**Community Development Facade Improvement Project:
224 North 7th Street**

Façade Improvement Project @ 224 North 7th Street, St. Joseph, MO

Addendum #1

NORTH ELEVATION

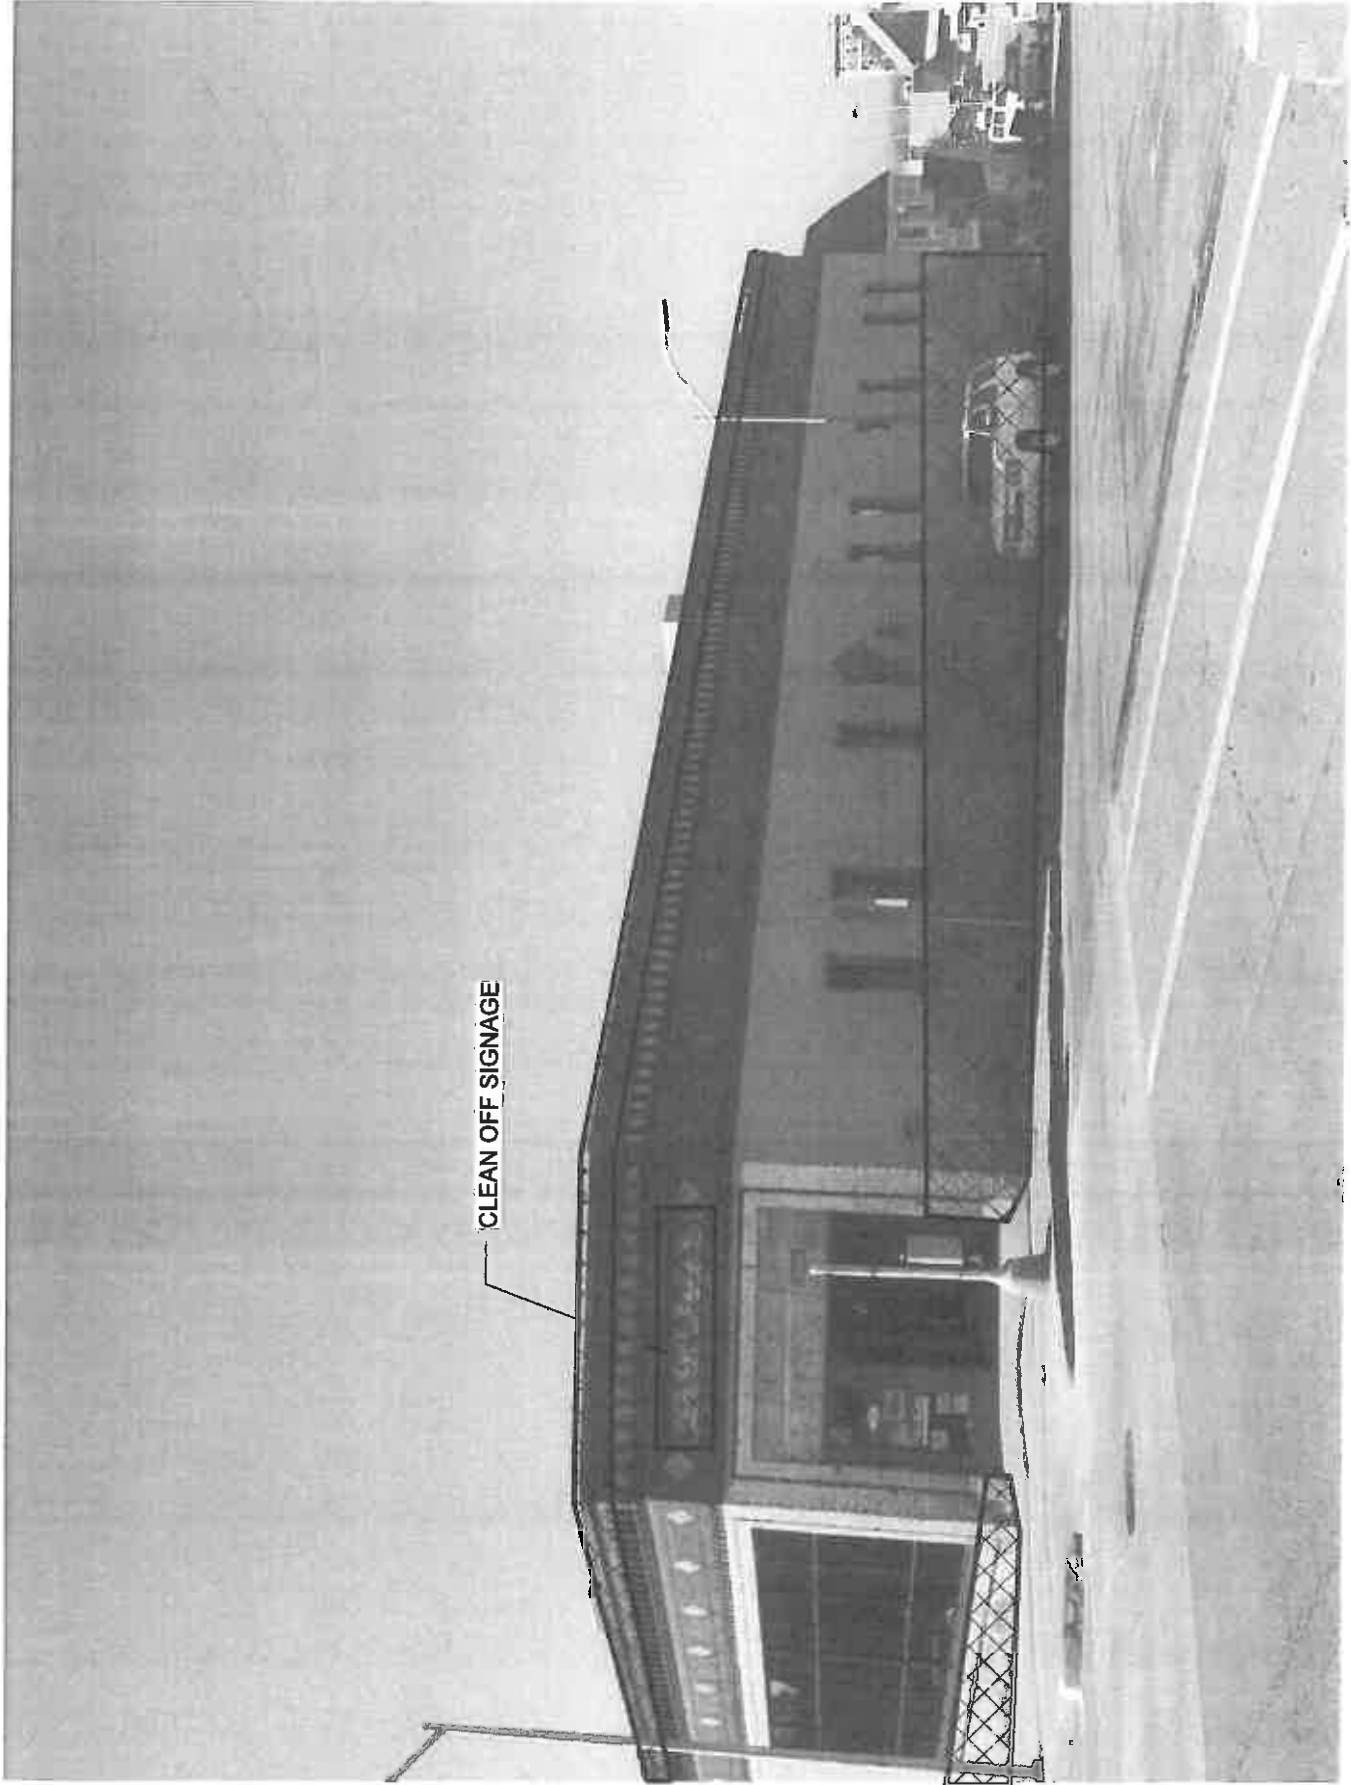
This work shall be that identified in the original specifications and include the signage area that is high on the angled wall that faces the northeast. * See attached picture

This work shall be that identified in the original specifications and include the signage area that is high on the angled wall that faces the northeast. * See attached picture

These areas are defined as the wall areas that are below the horizontal lines that intersect with the bottom sills of the windows. *See the attached picture that indicates the subject areas with black cross hatch markings.
